RCWD BOARD OF MANAGERS REGULAR MEETING AGENDA

Wednesday, April 11, 2018, 9:00 a.m.

WORKING DOCUMENT: This Engineer's report is a draft or working document of RCWD staff and does not necessarily reflect action by the RCWD Board of Managers

OAKWOOD PONDS GRADING, DEVELOPMENT & EROSION CONTROL PLANS BLAINE, MINNESOTA

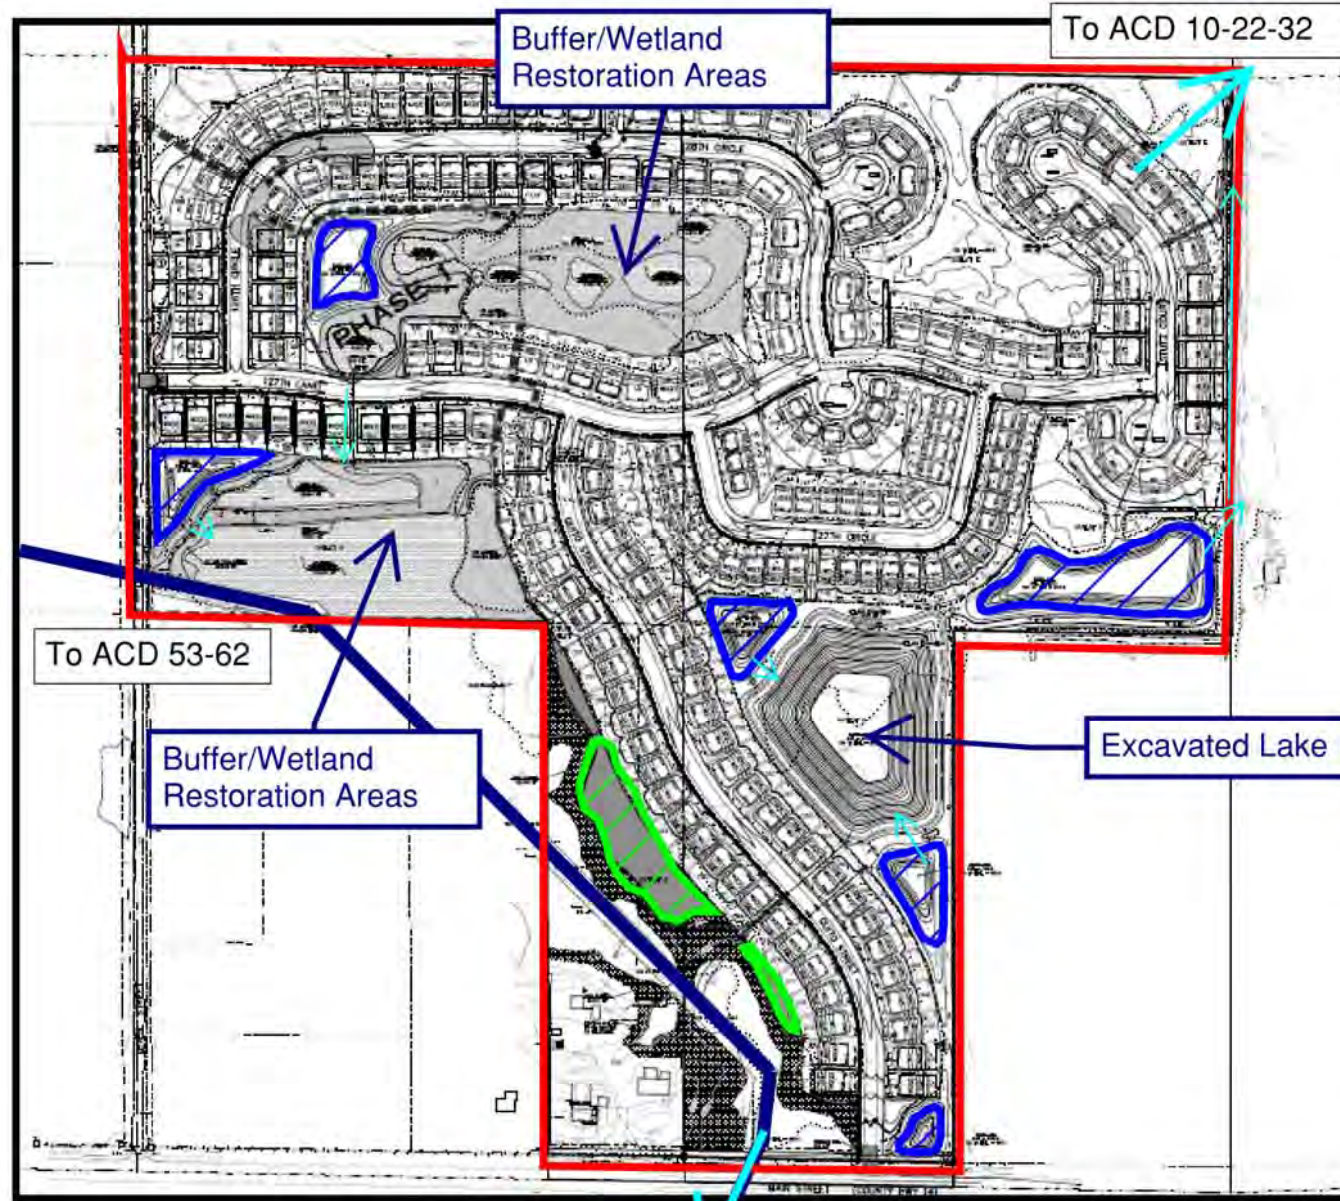
1. Submit the following information on the irrigation system per rule C.9(b)
 - a. Applicant must provide drainage diagrams showing the location of the 5.6 acres of pervious irrigation area.

- b. Applicant must provide final details of the irrigation system, including the delivery system and an operations plan.
2. The high water levels for Pond 400, Pond 500, Lake 1000 and Wetland 9 on the plans dated 3-9-18 do match the HydroCAD model dated 3-15-18. Applicant must revise final plans to match.
3. The emergency overflow (EOF) for Lake 1000 must include an identified EOF spillway sufficiently stabilized to convey flows for greater than the 100-year critical storm event.
4. Applicant must provide a topographic survey exhibit showing the adjusted boundary between the drainage area routed to drainage system ACD 53-62 and ACD 10-22-32 including acreage and any other changes.

- a. A detail needs to be added to sheet 10 including the revised outlet structure between Lake 1000 and Pond 400.
 - b. Sheets 6 and 7 of the plans must be updated with the revised outlet structure between Lake 1000 and Pond 400.
